Red Bluff Union Elementary School District

Form 470 # 240016414
RFP No. 2024-02

**REQUEST FOR PROPOSAL
DISTRICT CABLING UPGRADE
INTERNAL CONNECTIONS**

Addendum No. 1

BIDWELL

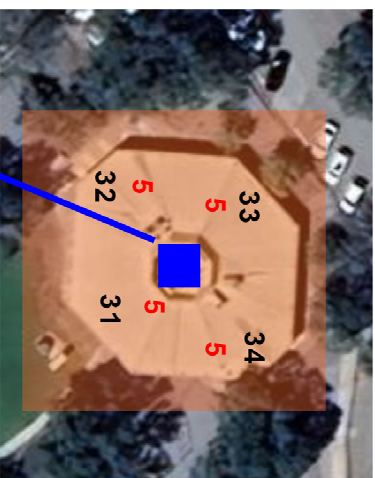
Q. Could a breakdown of drops-per-room be provided?

A. Yes. See the following maps specifying number of drops by room, and which IDF / MDF each room is to run back to.

All rooms in a given color shade to be served by IDF / MDF in that shaded area.

METTTEER

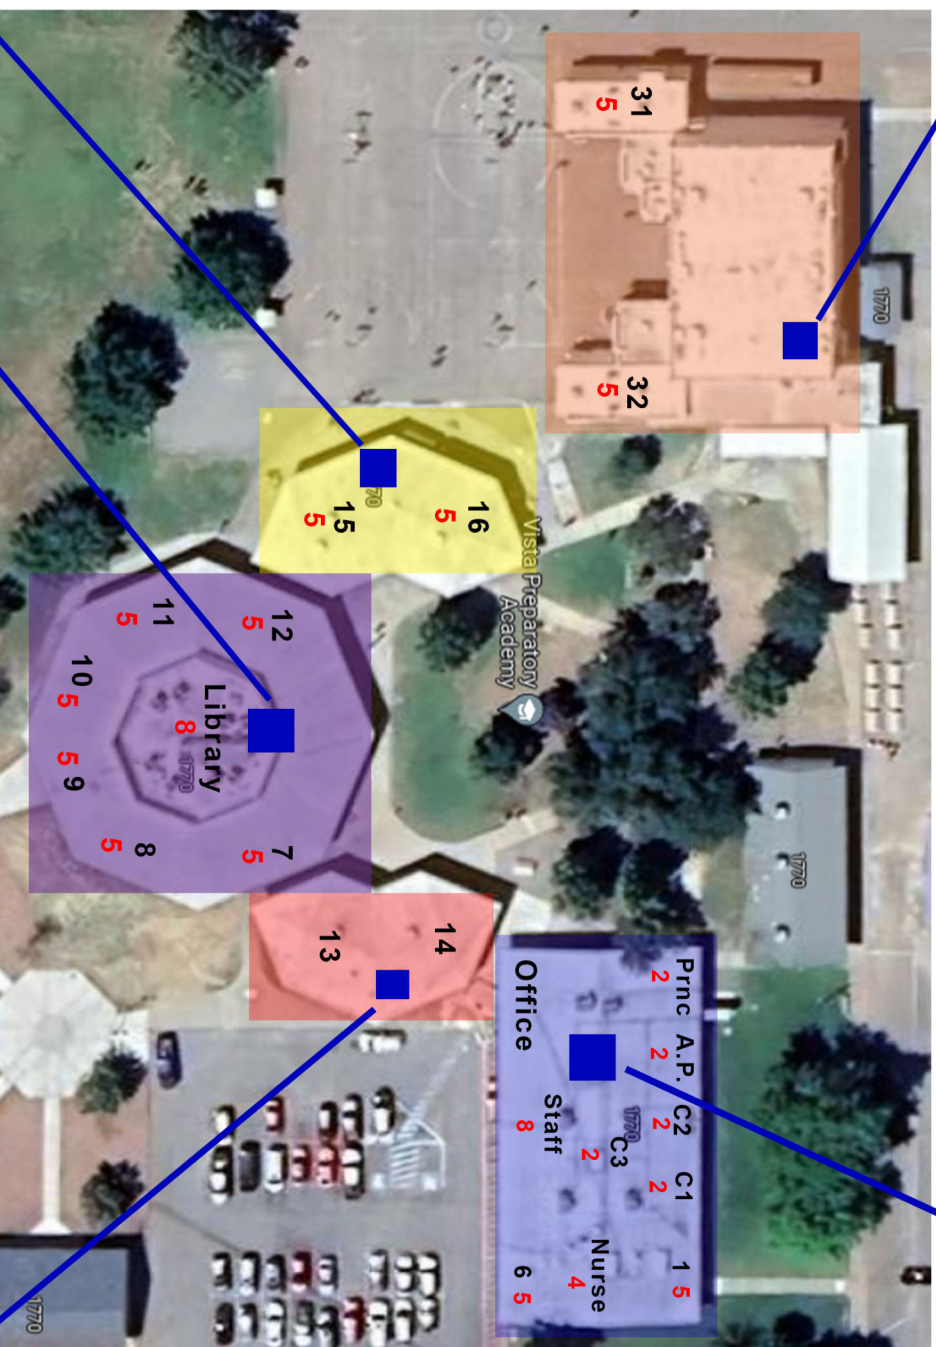
Q. Metteer Room 9 IDF: can the old analog telecom infrastructure (punchdown blocks, etc) be removed to make room for new IDF?

Q. Metteer Library IDF: can equipment be moved / adjusted to make room for new IDF.

A. YES.

A. Yes.

Room Numbers are in BLACK.
Drops required per room are in RED.
All rooms in a given color shade to be served by IDF / MDF in that shaded area.
